Design Refinement/Environmental Re-Evaluation Memo

**I-43: Brown Street to Capitol Drive
City of Milwaukee
Milwaukee County**

**Project ID: 1228-22-00
September 13, 2022**

Subject: I-43: Brown Street to Capitol Drive, Project Design ID: 1228-22-00

PROJECT NO: 1228-22-70	HWY: IH 43	COUNTY: MILWAUKEE	PROJECT OVERVIEW - REVISED	SHEET	E
------------------------	------------	-------------------	----------------------------	-------	----------

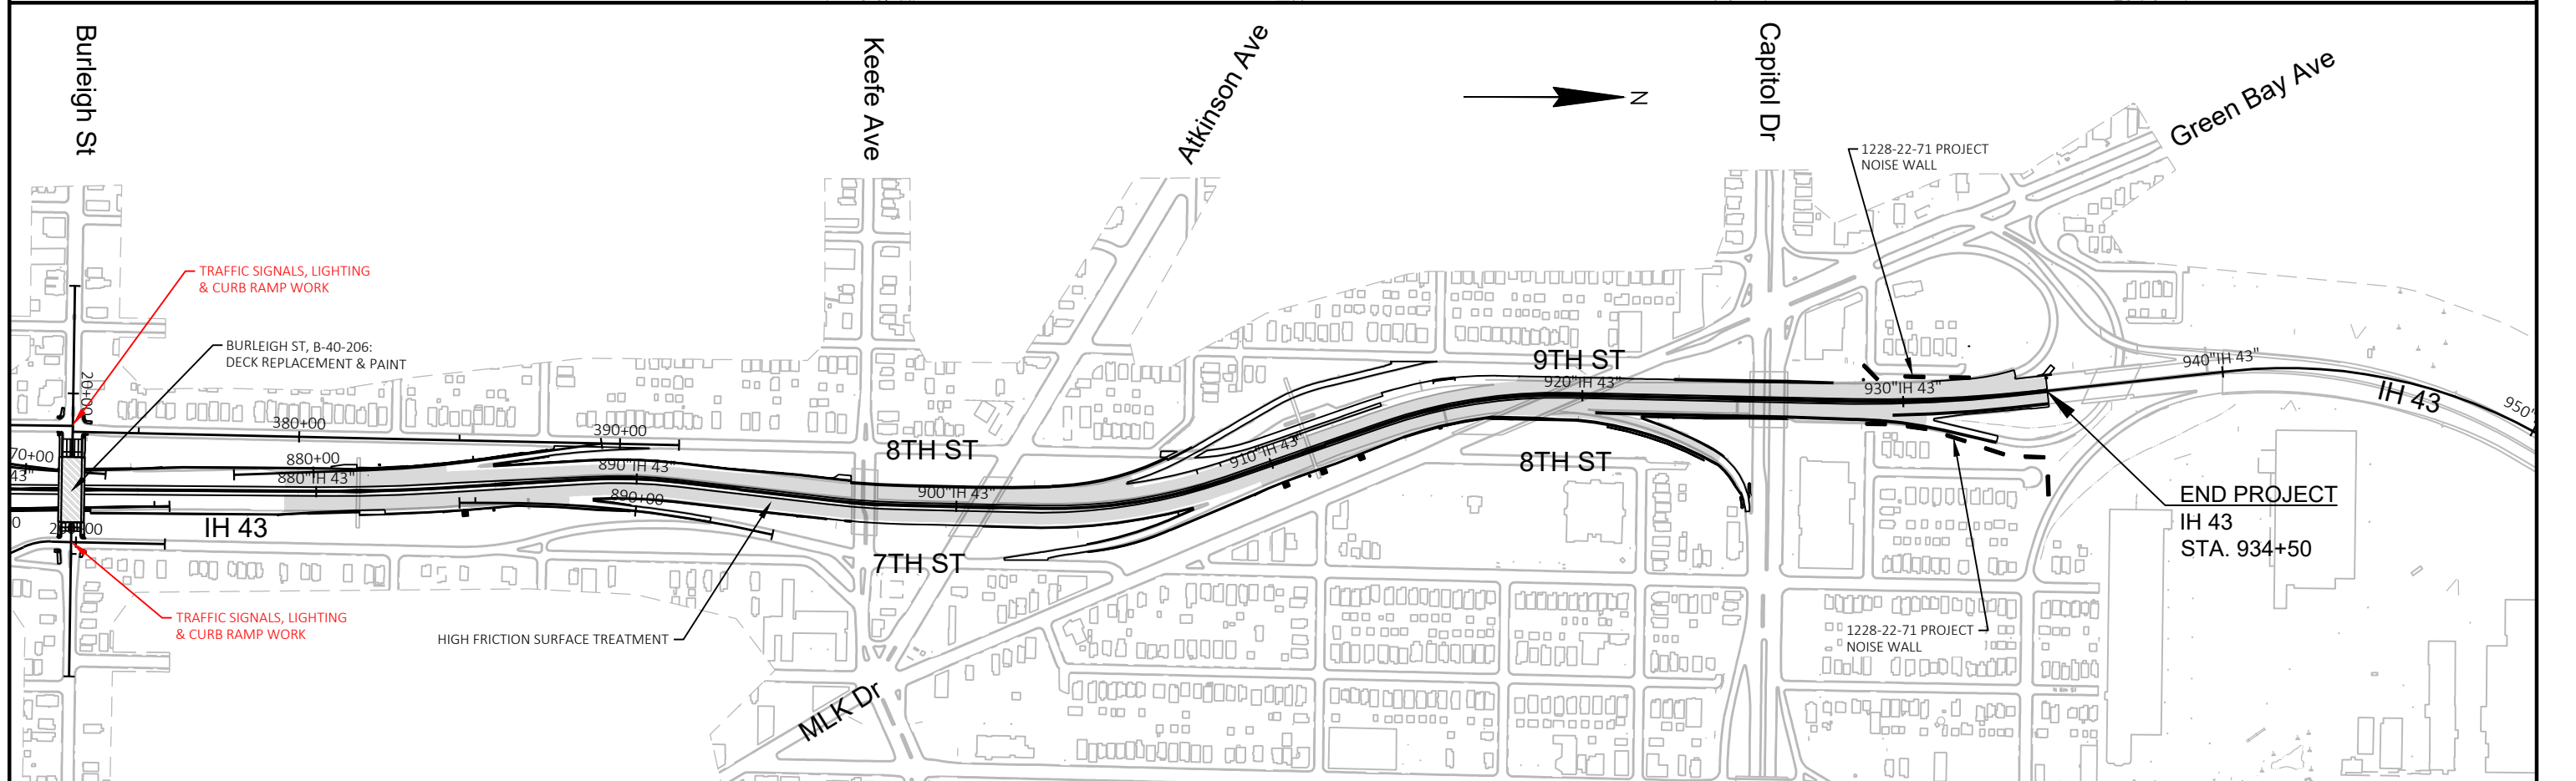
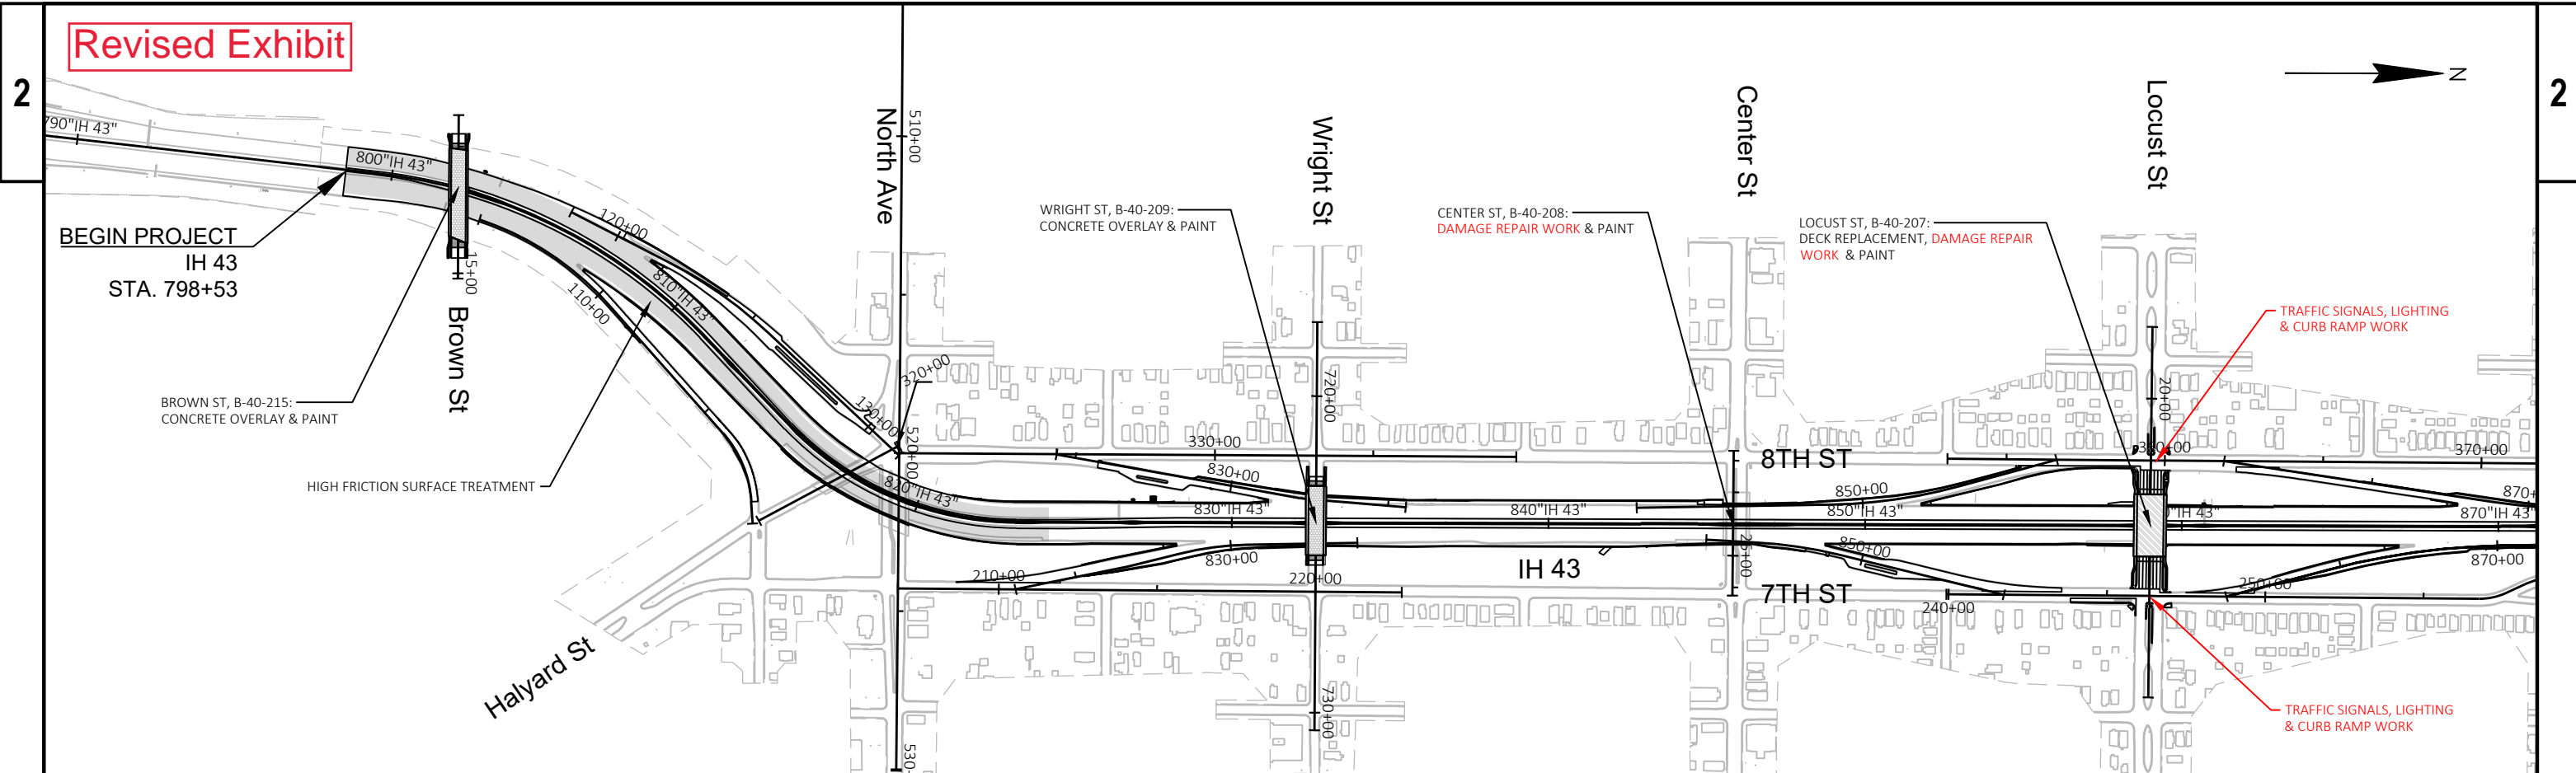
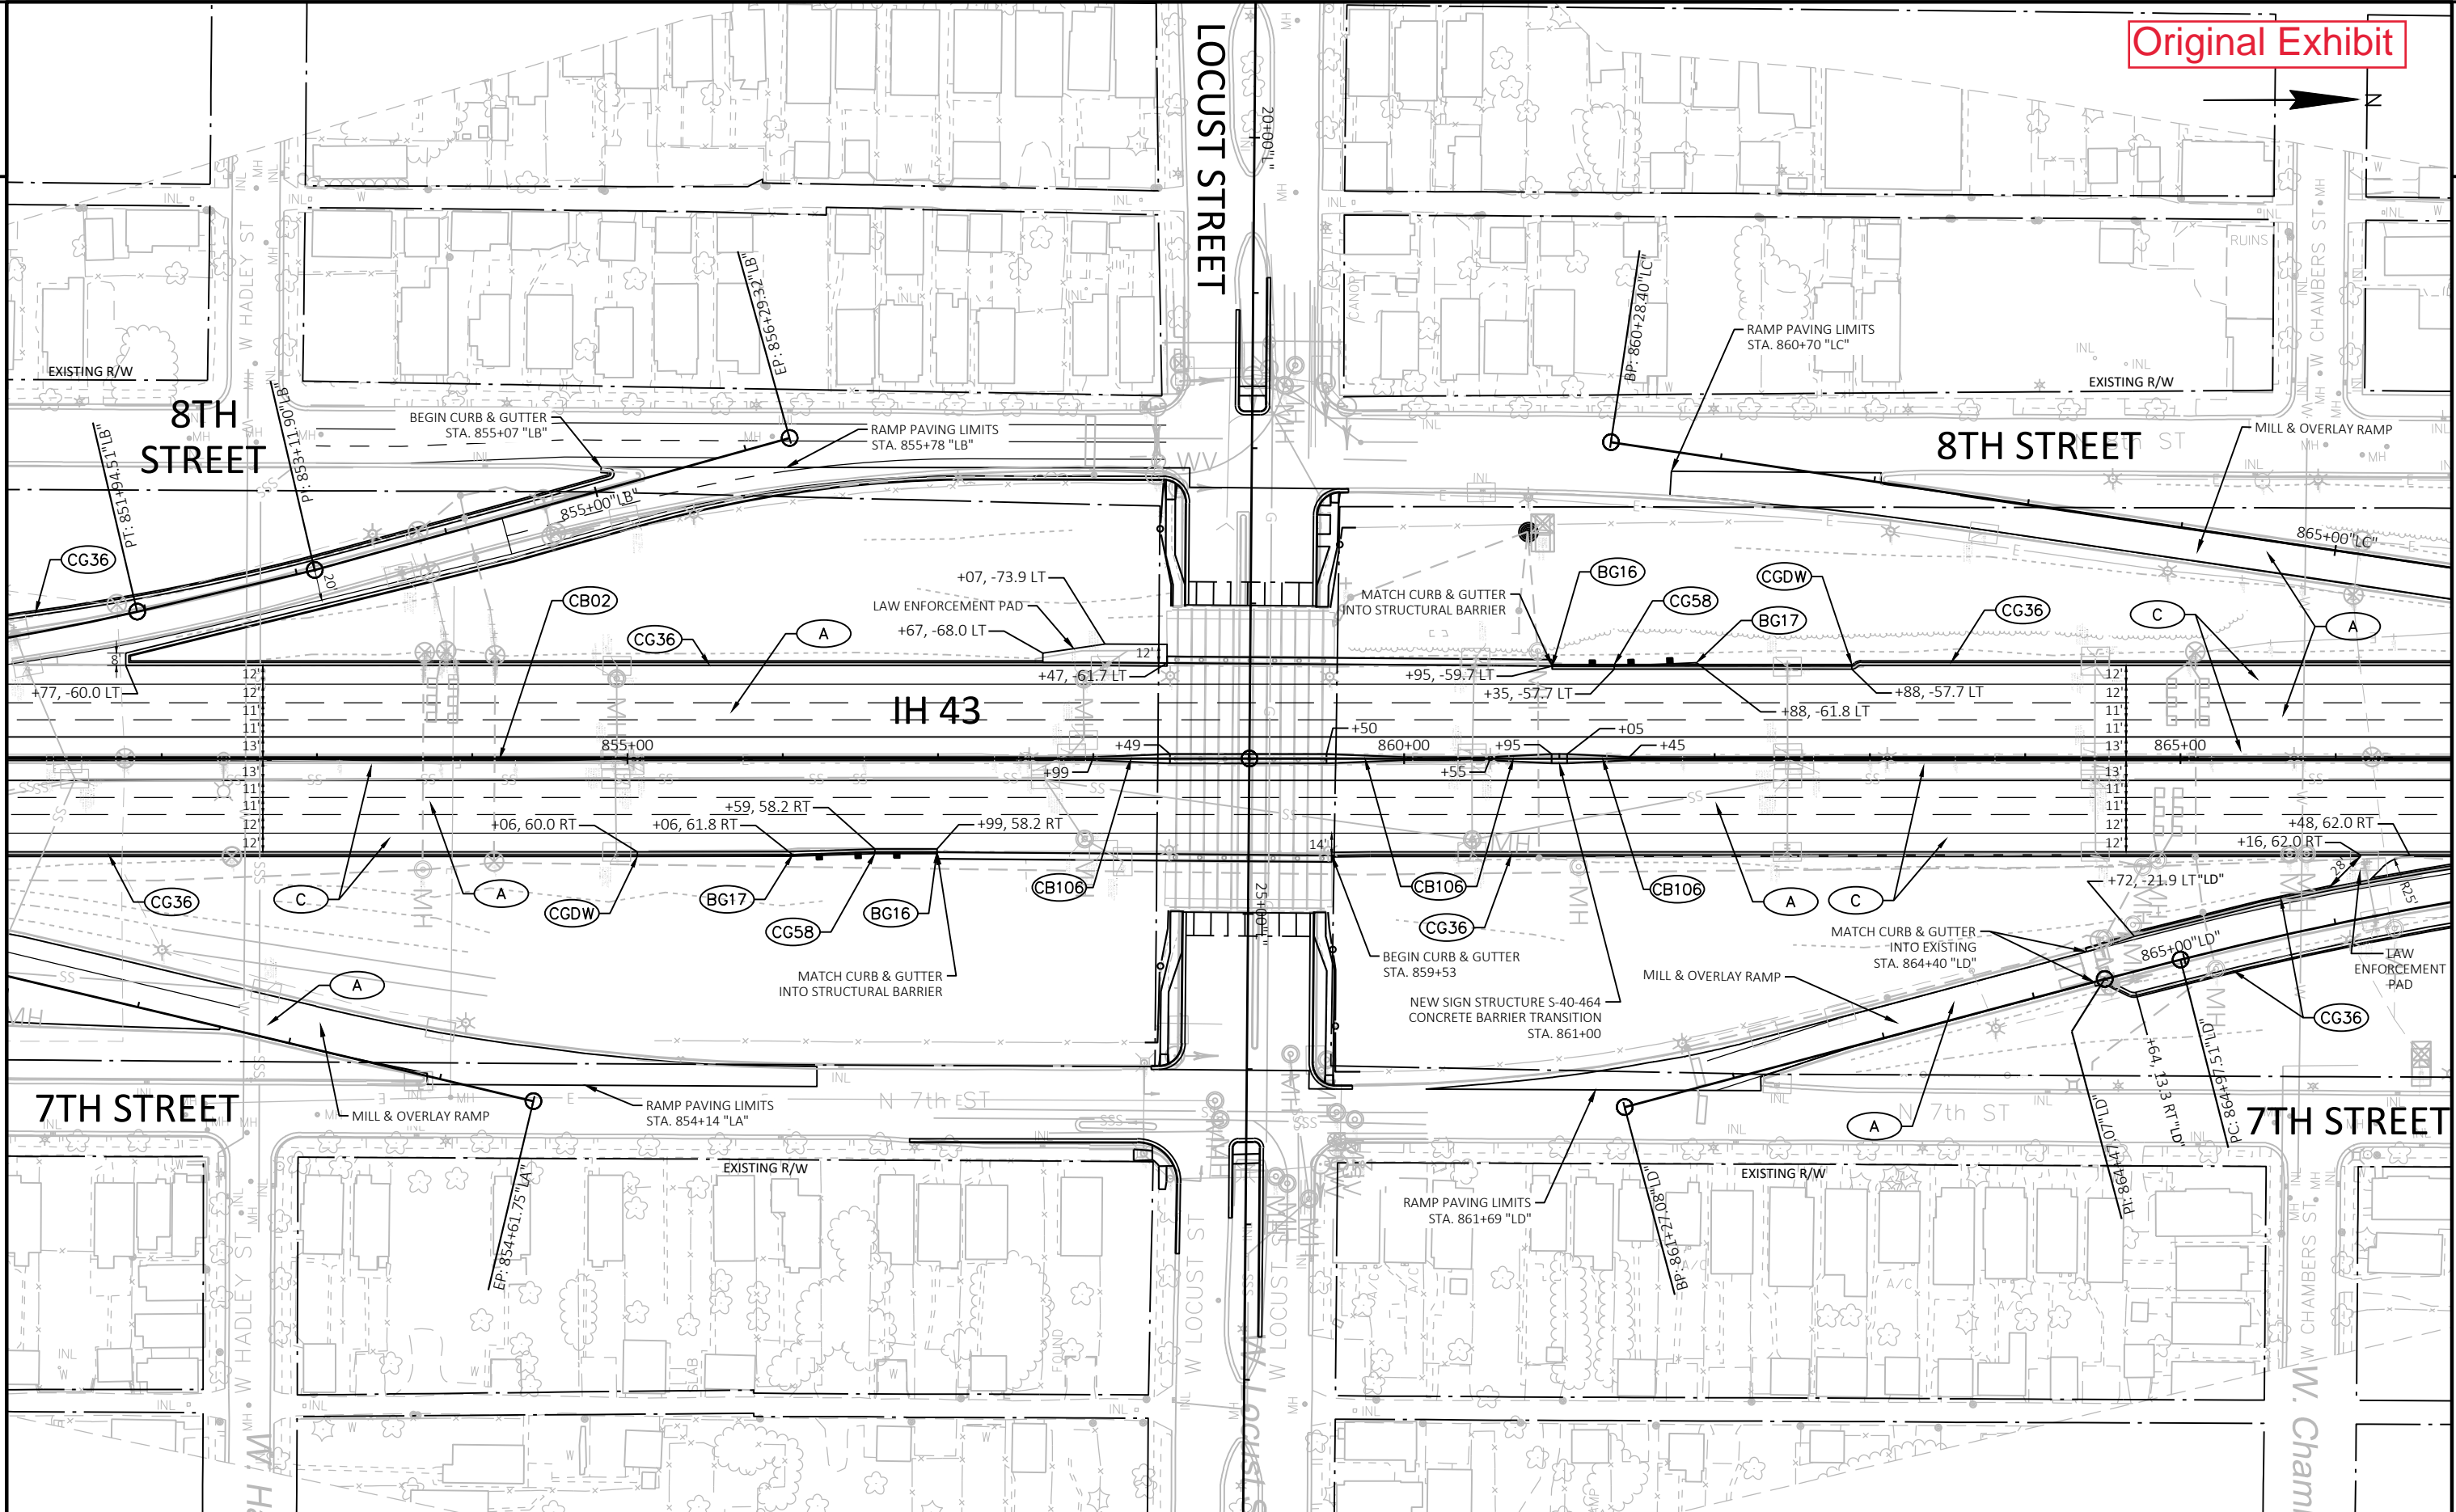
Traffic signals and curb ramps will be replaced as part of the bridge deck replacement work that is being completed on Locust Street and Burleigh Street at N. 7th Street and N. 8th Street. The deck replacement impacts lighting, traffic signals and interconnection at and between the intersections. Preliminary design coordination with the City of Milwaukee removed the raised medians over the bridges which impacted the median signal poles. The roadway profiles at Locust Street and Burleigh Street will need to be raised as part of the deck replacement.

Installation of the traffic signals will impact the existing curb ramps at the intersections, which will be upgraded to Americans with Disabilities Act (ADA)-compliant curb ramps. Five of the eight curb ramps were initially shown in the plans. The three curb ramps not

shown were also intended to be included in the scope but were missing pending additional survey required to complete the design. Lighting/conduit will be installed along Locust Street and Burleigh Street from N. 8th Street to N. 7th Street.

Two bridges (B-40-207; Locust Street over I-43 and B-40-208; Center Street over I-43) located within the project limits were struck by vehicles in 2020, causing damage to the bridges. One vehicle struck both bridges on the southbound side of I-43 and another vehicle struck B-40-208 on the northbound side of I-43. WisDOT Bureau of Structures (BOS) had determined that no immediate repairs needed to be done at the time but recommended that gouges get ground out and heat straightening be performed on the bridges. With other work being performed on both structures, WisDOT is proposing to include this work as two separate construction IDs (1228-22-80 and 1228-22-81) under this project's design ID. This bridge damage repair project is 100% state-funded and will be reimbursed by the damaging vehicles' insurance claims.

The original plan set overview sheet from the ER and a revised version with the complete scope are attached as Exhibit 1. More detailed plan sheets, consisting of the original provided in the Section 106 amendment and revised plan sheet, are attached in Exhibit 2.
